## STORMWATER MANAGEMENT FACILITIES OPERATION AND INSPECTION REPORT

Quarter Section SW 1/4 Sec 23 Name of Business/Subdivision Little League Complex  
Property Tax ID Number 0091.999 Address of Property Adjacent to Mill Road

Description: SWP 235 002 Location Of Pond Pond #002, See Attached map for location.

Inspector Name: Bryan Greisch  
Inspection Date: August 17, 2011

#2 - Upstream end of outfall, minor erosion around AEW

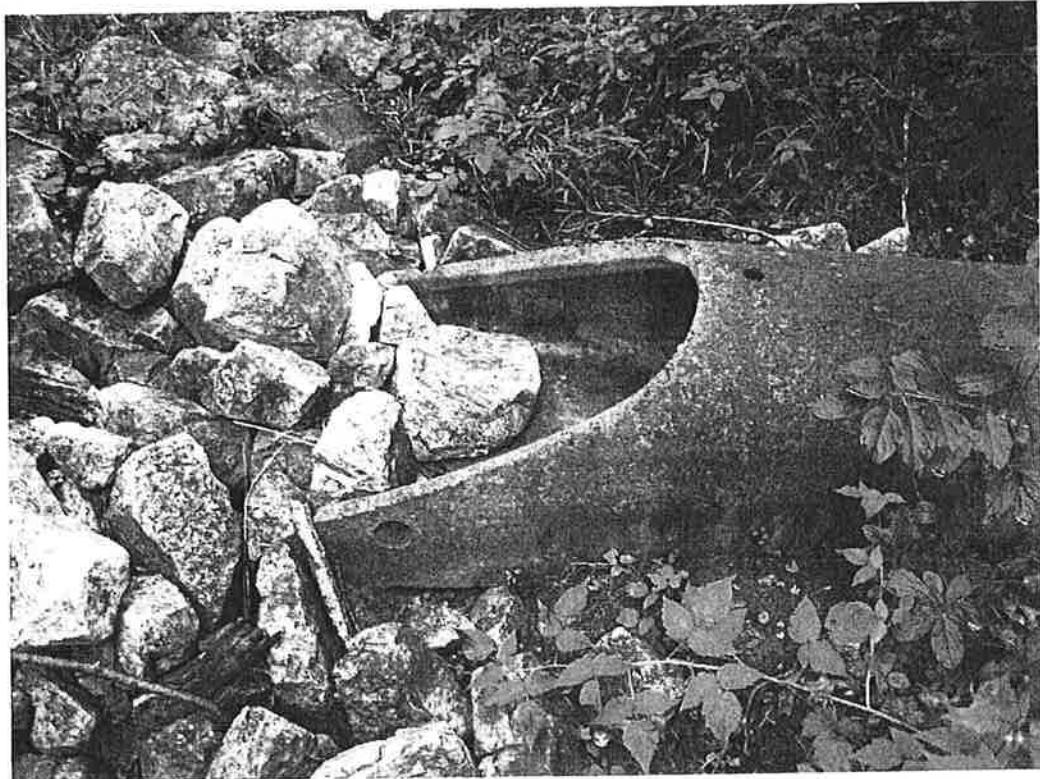
Compliance Verification	Design	Actual	Compliant Yes	No	Comments (Condition of Structure)
<b>Primary Outlet Pipe</b>					Outlet Pipe Material – Reinforced Concrete
Opening Diameter (inches)	12"		Yes		Upstream Outlet – Picture #2 – Minor Erosion around Apron Endwall.
Upstream Invert	815.40	816.70	No		Downstream Outlet – Picture #3 – Good
Downstream Invert	814.98		Yes		
Length (feet)	72'		Yes		
Slope (%)	0.50%		Yes		
<b>Secondary Outlet Pipe</b>	(If Applicable)		Outlet Pipe Material		
Opening Diameter (inches)					
Upstream Invert					
Downstream Invert					
Length (feet)					
Slope (%)					
<b>Riser</b>	(If Applicable)		Riser Material		
Opening Diameter (inches)					
Elevation					
<b>Upper Discharge Control</b>	(If Applicable)				
Opening Diameter (inches)					
Elevation

#3 - Standing on top of Upstream outlet, silt fence, debris in front of pipe, does not look like AEW was put in or it was pulled out.

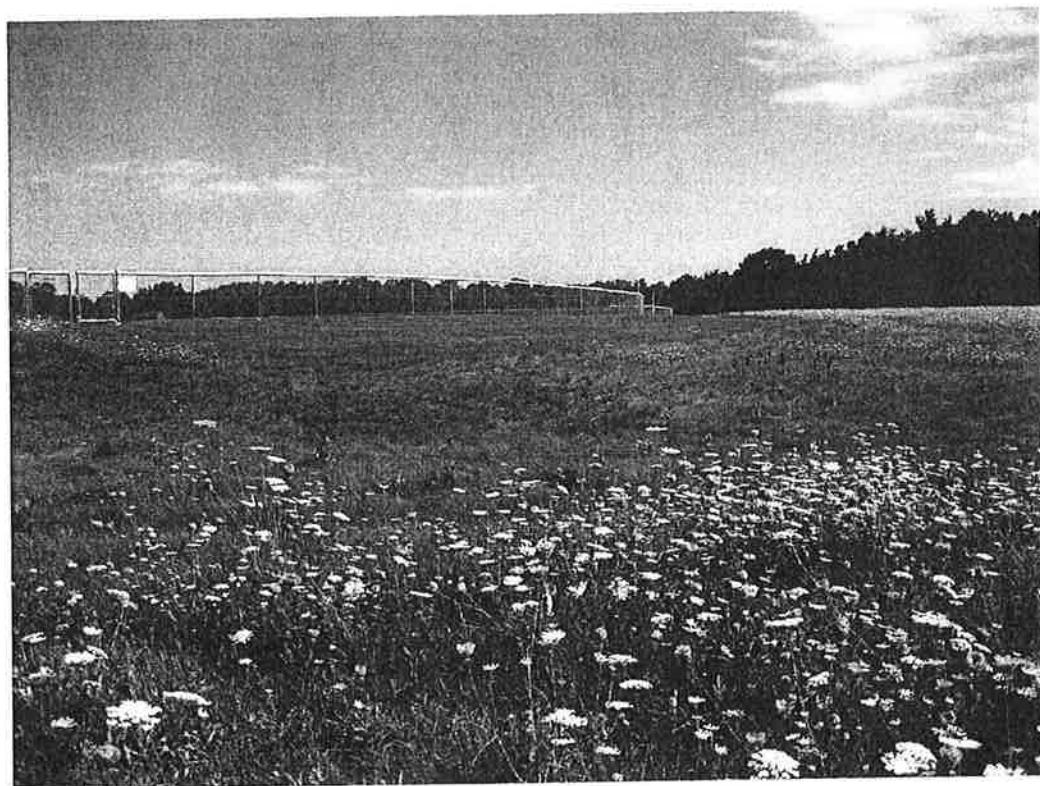
Compliance Verification	Design	Actual	Compliant Yes	Non-Compliant No	Comments (Condition of Structure)
<b>Primary Outlet Pipe</b>					Outlet Pipe Material – Reinforced Concrete
Opening Diameter (inches)	15"		Yes		Upstream Outlet – Picture #3 – Silt fence, Debris in front of pipe, no Apron Endwall.
Upstream Invert	812.40	814.01	No		Downstream Outlet – Picture #4 – Rocks & Silt Fence in Apron Endwall, minimal riprap.
Downstream Invert	811.98		Yes		
Length (feet)	72'		Yes		
Slope (%)	0.50%		Yes		
<b>Secondary Outlet Pipe</b>	(If Applicable)		Outlet Pipe Material		
Opening Diameter (inches)					
Upstream Invert					
Downstream Invert					
Length (feet)					
Slope (%)					
<b>Riser</b>	(If Applicable)		Riser Material		
Opening Diameter (inches)					
Elevation					
<b>Upper Discharge Control</b>	(If Applicable)				
Opening Diameter (inches)					
Elevation

#1 - Storm outfall #2, South side of pond, Minor erosion around riprap, riprap push down slope.

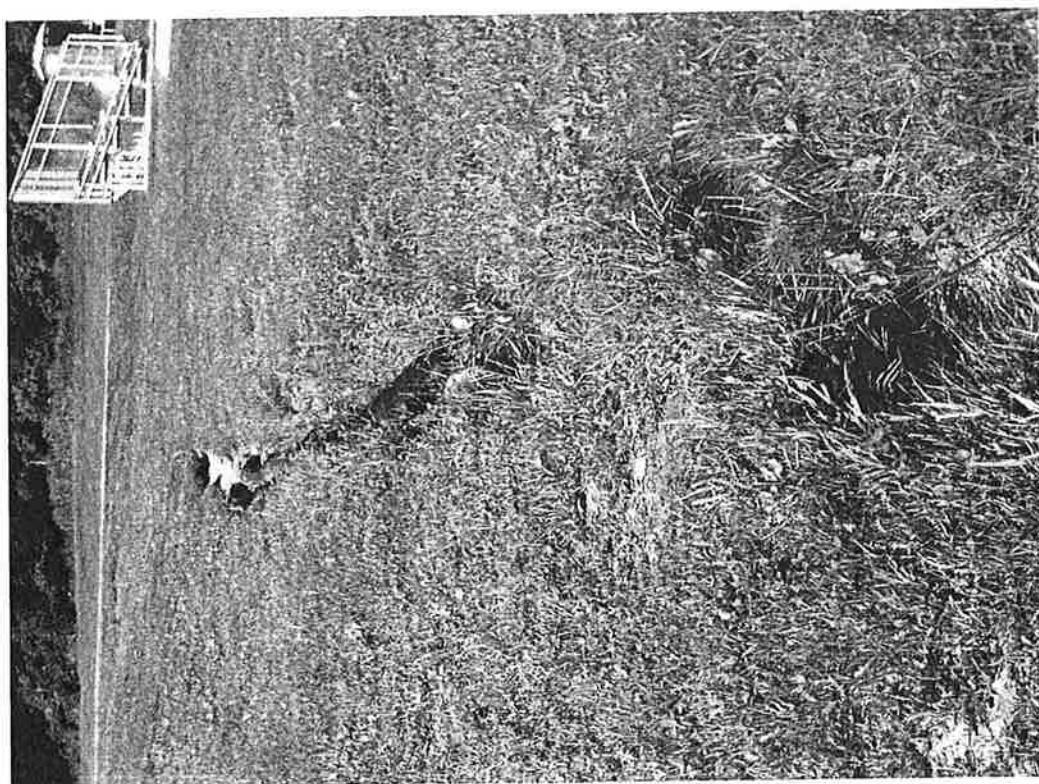
#2 - Storm outfall #1, SE corner of pond, minor areas of dead grass around riprap.

#3 - Low spot in SE corner of pond.

#4 - Storm outfall #3, SW corner of pond, ground eroded away on top of pipe and in front of pipe.

Outfall 3 & 4	8" corrugated plastic	SW Corner & West Side		Pic. #4 & 5 pipe exposed from erosion							
<b>Storage Properties</b>		Design	Actual	Compliant Yes      No	Not Applicable	Comments					
Normal Water Elevation (Wet Ponds)						Low spot on SE corner of pond, regrade to flow. Baseball field built in SW corner of pond, so it will affect pond storage from original design.					
Design High Water Elevation											
Area at Normal Water Elevation (Ac) (Wet Ponds)											
Area at Design High Water Elevation (Ac)											
Active Storage Available (Ac-Ft)*											
Lowest Elevation at Top of Embankment (If Applicable)	816.00										
Average Elevation at Top of Embankment (If Applicable)											
Maximum Bottom Elevation											
Average Pond Bottom Elevation											
Pond Bottom Area (Ac)											
Maximum Pond Depth	3.50'	3.02'									
Average Pond Depth											
Average Permanent Pool Depth (Wet Ponds)

#7 - Upstream end of outfall, debris caught in AEW.

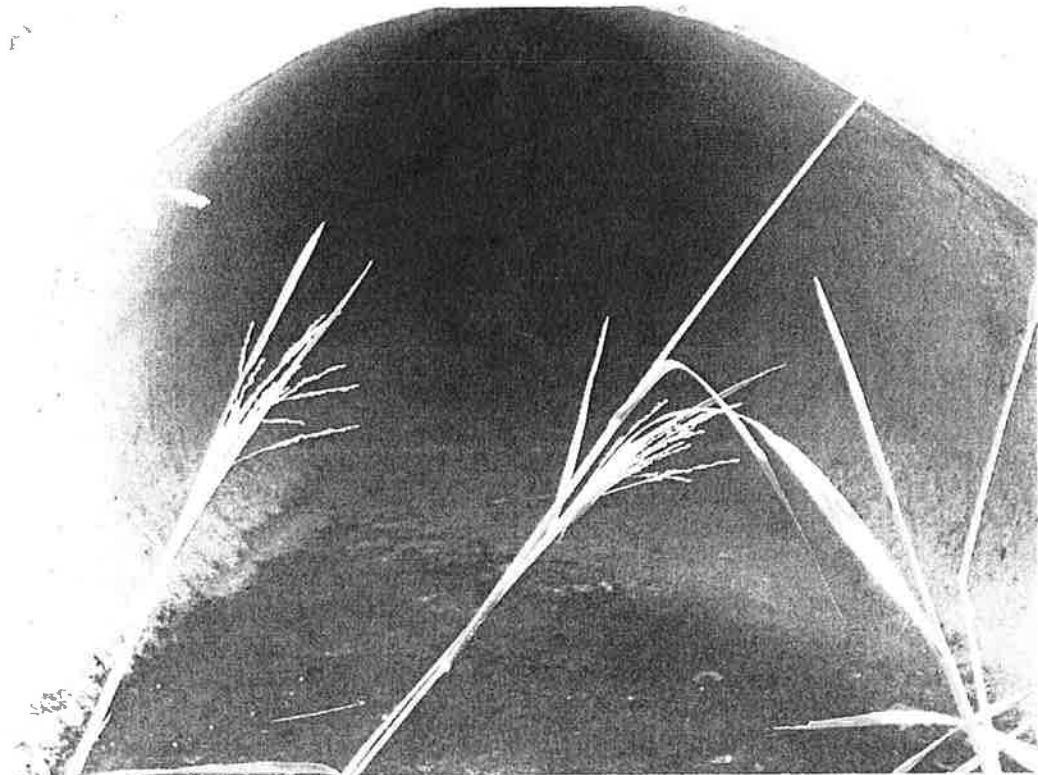
Compliance Verification	Design	Actual	Compliant		Comments (Condition of Structure)
			Yes	No	
<b>Primary Outlet Pipe</b>					Outlet Pipe Material – Reinforced Concrete
Opening Diameter (inches)	15"		Yes		Upstream Outlet – Picture #6 & 7 – minor vegetation around Apron Endwall, Debris in Endwall.
Upstream Invert	811.50	811.98	Yes		
Downstream Invert	810.98		Yes		Downstream Outlet – Picture #9 – Hole next to outfall, could be from animal, did not look like from erosion.
Length (feet)	98'		Yes		
Slope (%)	0.50%		Yes		
<b>Secondary Outlet Pipe</b>	(If Applicable)		Outlet Pipe Material		
Opening Diameter (inches)					
Upstream Invert					
Downstream Invert					
Length (feet)					
Slope (%)					
<b>Riser</b>	(If Applicable)		Riser Material		
Opening Diameter (inches)					
Elevation					
<b>Upper Discharge Control</b>	(If Applicable)				
Opening Diameter (inches)					
Elevation

#6 - Upstream end of outfall, minor vegetation around outfall.

#3 - Upstream end of outfall, AEW separated from pipe.

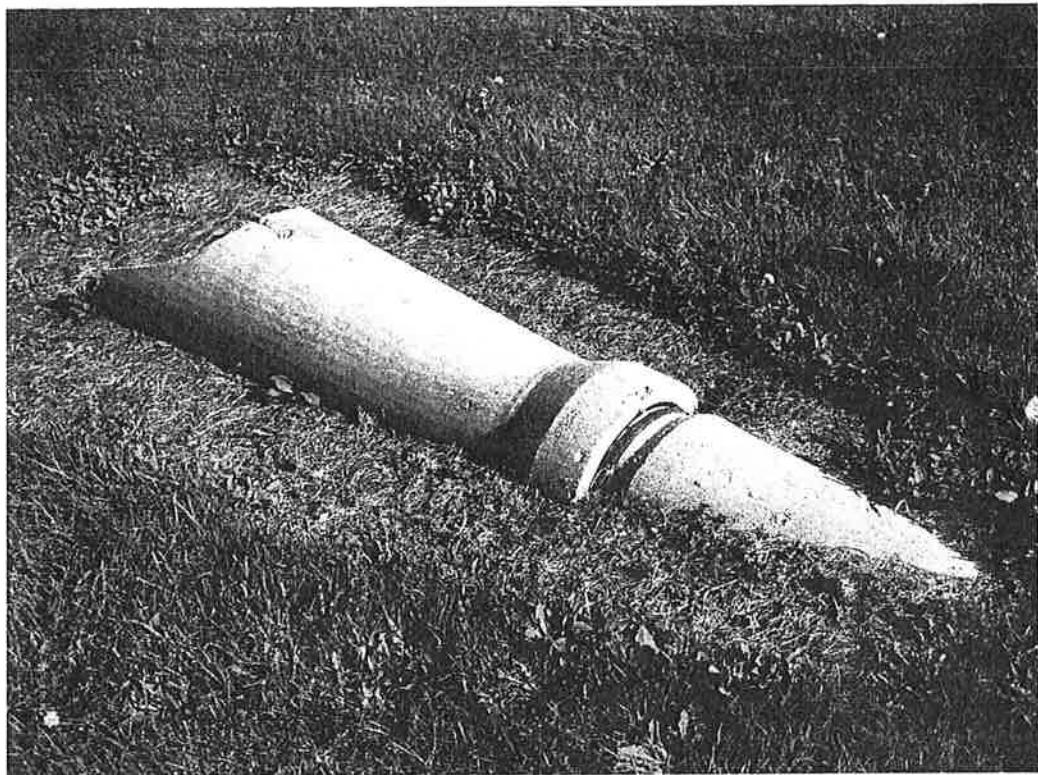
Compliance Verification	Design	Actual	Compliant Yes	Non-Compliant No	Comments ( Condition of Structure)
<b><i>Primary Outlet Pipe</i></b>					
Opening Diameter (inches)	12"		Yes		Outlet Pipe Material – Reinforced Concrete
Upstream Invert	819.10	819.27	Yes		Upstream Outlet – Picture #3 & 4 – Apron Endwall & Pipe separated, Riprap rocks in AEW, dead grass around endwall
Downstream Invert	818.84	818.83	Yes		Downstream Outlet – Picture #1 & 2 – Top of Apron Endwall & Pipe Broken out, minor overgrowth of riprap.
Length (feet)	50'		Yes		
Slope (%)	0.50%		Yes		
<b><i>Secondary Outlet Pipe</i></b>					
Opening Diameter (inches)					Outlet Pipe Material
Upstream Invert					
Downstream Invert					
Length (feet)					
Slope (%)					
<b><i>Riser</i></b>					
Opening Diameter (inches)					Riser Material
Elevation					
<b><i>Upper Discharge Control</i></b>					
Opening Diameter (inches)					
Elevation

#2 - Downstream end of outfall, riprap getting grown in.

#5 - Emergency Spillway built to the right of outfall, designed to be on top of outfall.

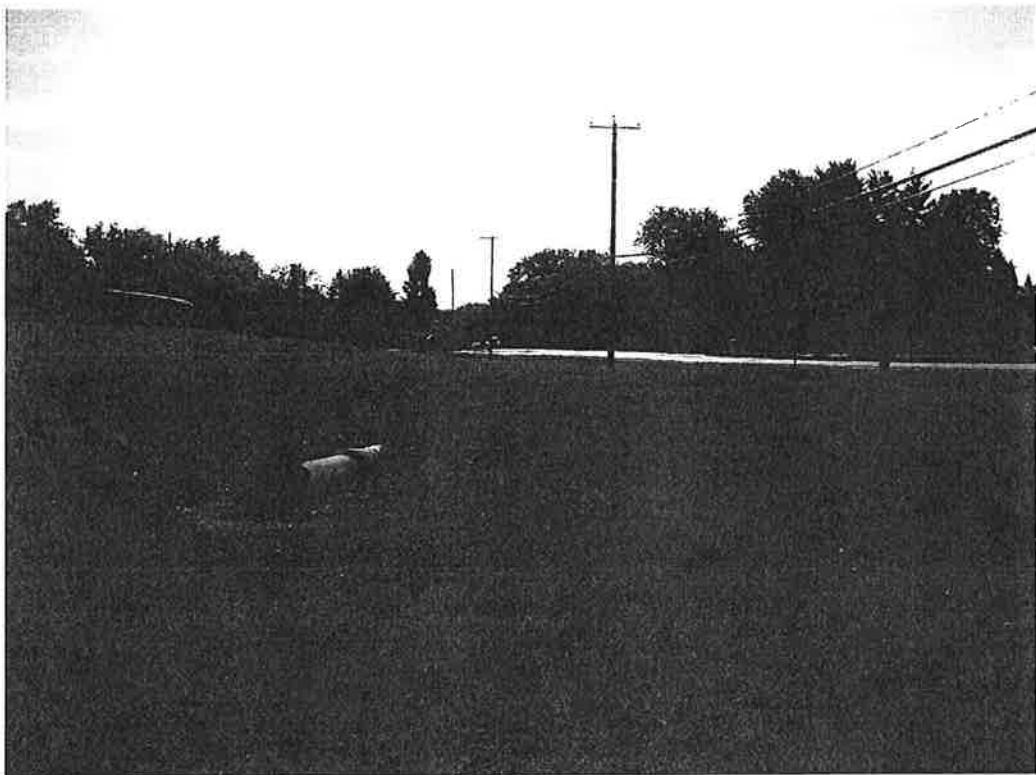
Compliance Verification	Design	Actual	Compliant Yes	No	Comments
<b>Lower Discharge Control</b>	(If Applicable)				
Opening Diameter (inches)					
Elevation					
<b>Other (Description)</b>					
Opening Type and Size (inches)					
Elevation					
<b>Emergency Spillway</b>					
Elevation	823.00	821.28	No		Picture #5, Spillway looks like built to the right of
Length of spillway (feet)			Yes		Outlet, design show it to be over outlet.
<b>Embankment</b>	Present Yes      no		Comments/Maintenance Requirements		
Unauthorized Plantings, trees, or woody vegetation		No	Landscape plan does not show pond in this area, so trees do not match plan, but no issue with trees planted. Embankment along		
Animal burrows or slope erosion		No	Mill road seems low compared to what was designed. Picture #6		
<b>Storm Sewer Outfalls</b>	Type & Size		Location		Comments
Outfall 1					
Outfall 2					
Outfall 3					
<b>Storage Properties</b>	Design	Actual	Compliant Yes	No	Not Applicable

#4 - Upstream end of outfall, Riprap rocks in AEW, grass died around AEW

#6 South Embankment looking west, seems to be lower than what was designed.

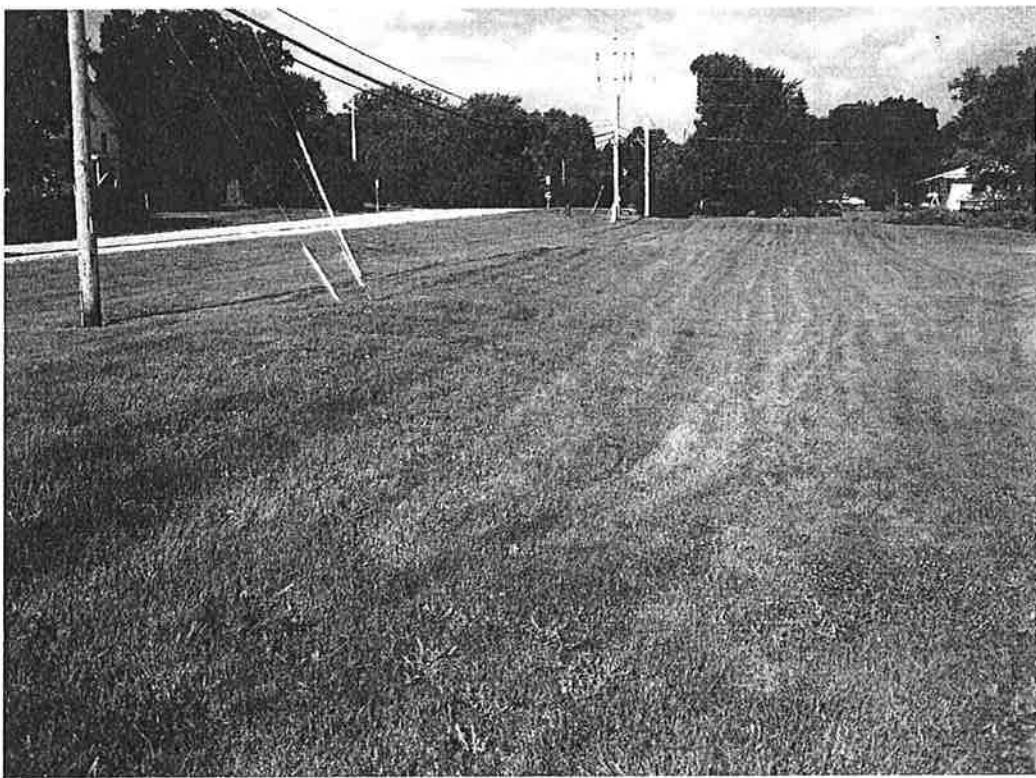
Normal Water Elevation (Wet Ponds)					
Design High Water Elevation					
Area at Normal Water Elevation (Ac) (Wet Ponds)					
Area at Design High Water Elevation (Ac)					
Active Storage Available (Ac-Ft)*					
Lowest Elevation at Top of Embankment (If Applicable)	824.00	821.98		No	
Average Elevation at Top of Embankment (If Applicable)					
Maximum Bottom Elevation					
Average Pond Bottom Elevation	820.00	820.00	Yes		
Pond Bottom Area (Ac)					
Maximum Pond Depth	3.70'	2.01'		No	
Average Pond Depth					
Average Permanent Pool Depth (Wet Ponds)
